ROCKY FLATS ENVIRONMENTAL TECHNOLOGY SITE FINAL PHASE I RFI/RI WORK PLAN OPERABLE UNIT 8 700 AREA	Manual No.: Section No.: Page: Organization: Effective Date:	21100-WP-OU 8.01 Table of Contents, R1 1 of 2 Environmental Management 2/01/95
--	---	---

**TABLE OF CONTENTS
PHASE I RFI/RI WORK PLAN FOR OPERABLE UNIT 8
700 AREA**

25. DMR No. 95-DMR-ERM-000

4. Document Number/Revision: 21100-WP-OU8.01/Rev. 0
5. Document Title: Environmental Restoration Program Phase I RFI/RI Work Plan Operable Unit No. 8 700 Area

FIGURE 2-6
IHSS 135

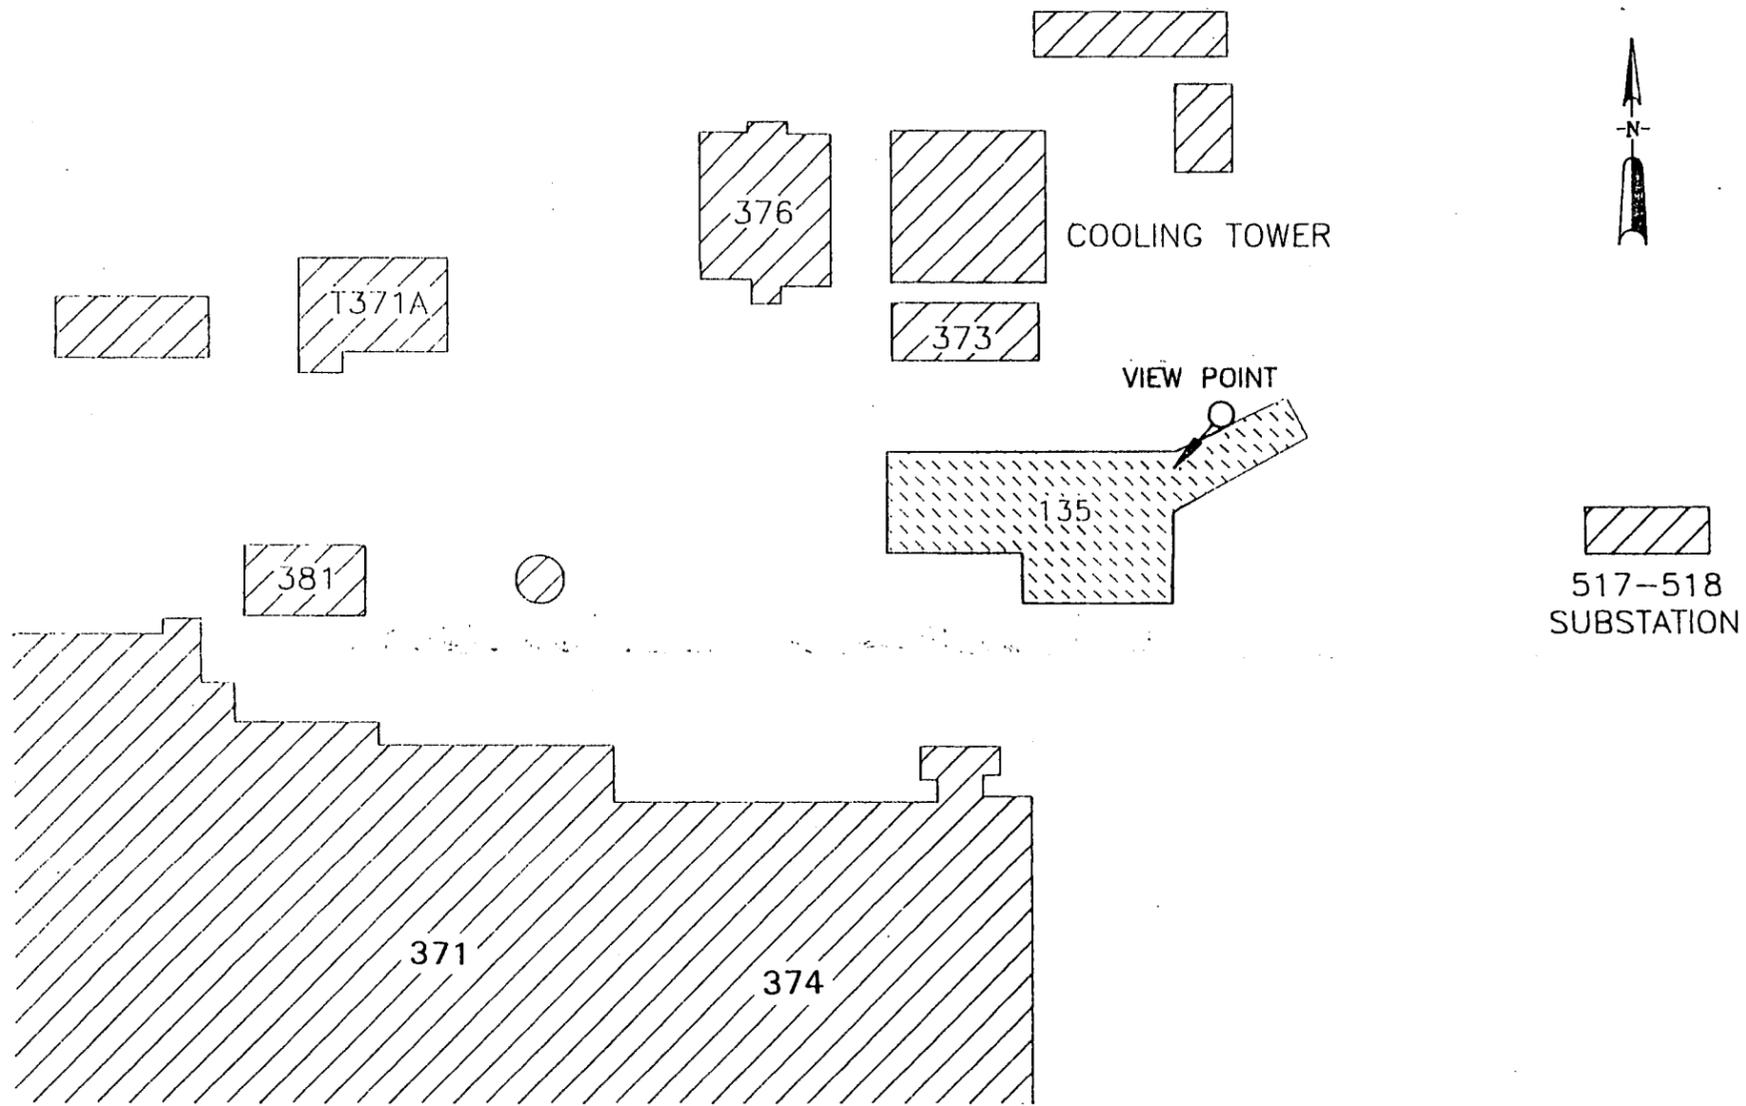
8. Item	9. Page	10. Step	11. Proposed Modifications
9	Sec. 2		Replace the following figures at the end of Section 2: Figure 2-2 (p. 240), Figure 2-3 (p. 241), Figure 2.6 (p. 244), Figure 2-8 (p. 246), Figure 2-9 (p. 247), Figure 2-17 (p. 255), Figure 2-21 (p. 259), Figure 2-24 (p. 262), Figure 2-26 (p. 264)
10	Sec. 6 41	6.5.4	In the last line of the last paragraph on this page, remove the beginning of the sentence "If soil borings are required" to have the sentence begin "TM 2 will specify the..."
11	Sec. 6 46	6.5.9	Redo sentence two and add sentences three and four before the sentence beginning "Additionally...": "The subsurface has been affected at both of these sites due to sewer line breaks associated with four underground waste holding tanks located north of Building 776 and east of Building 701 in a small structure identified as Building 730. They are designated as Tanks 776 A through D. They were built in approximately 1956 (Rockwell, 1976) and were taken out of service in the 1980s."

FIGURE 8-1

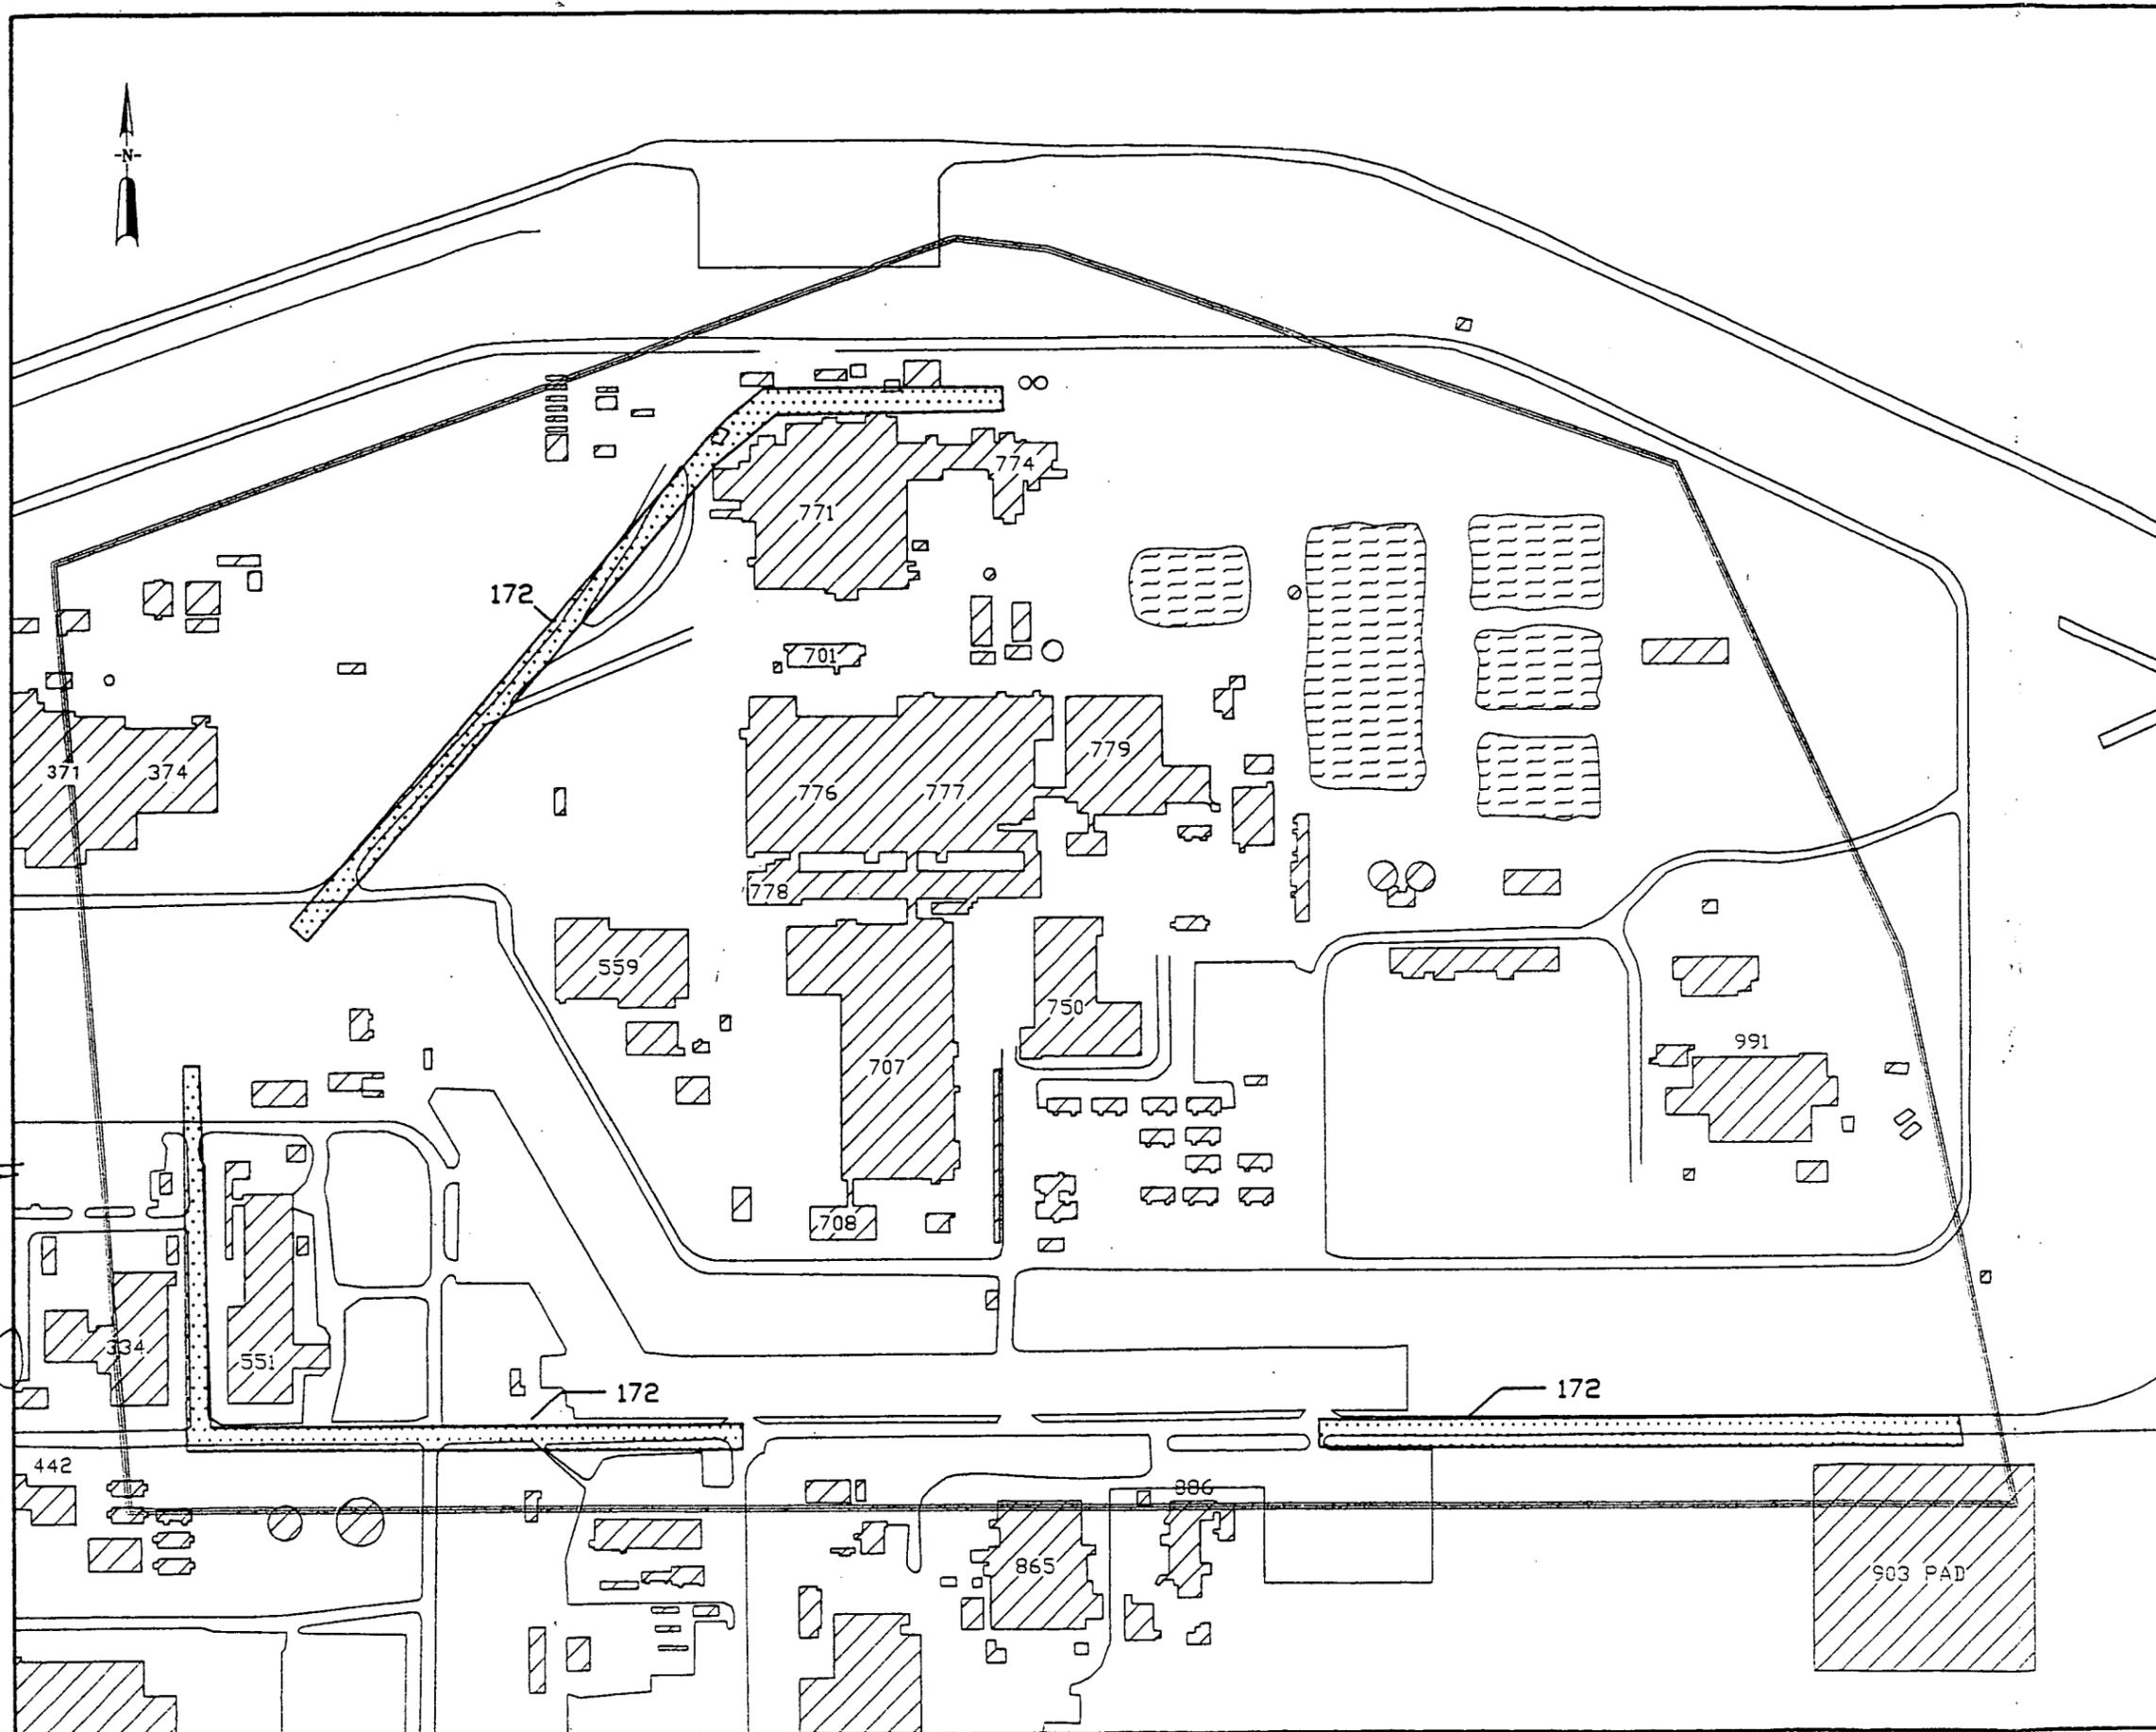
12	Sec. 6 54	6.5.18	At the end of paragraph two add: "The logic for looking for the slab first is that the slab should be easy to locate using geophysical methods and once located a sampling plan will be developed from the slab area back towards the original location. The historical account of how the slab was buried indicated that following decontamination the slab was pushed a short distance north of its original location into a ditch and used as fill. Thus, once the slab is located, the original location can be investigated more precisely (see Section 2.3.20)."
13	Sec. 6		Replace the following Figures at the end of Section 6: Figure 6-4 (p. 90), Figure 6-5 (p. 91), Figure 6-8 (p. 94), Figure 6-9 (p. 95), Figure 6-14 (p. 100) <i>90</i>
14	Sec. 7		Replace pages 2 & 3 with the new "Final OU 8 RFI/RI Work Plan and Field Implementation Schedule"
15	Sec. 8		Replace the following Figure at the end of Section 8: Figure 8-1 (p. 28) <i>26</i>
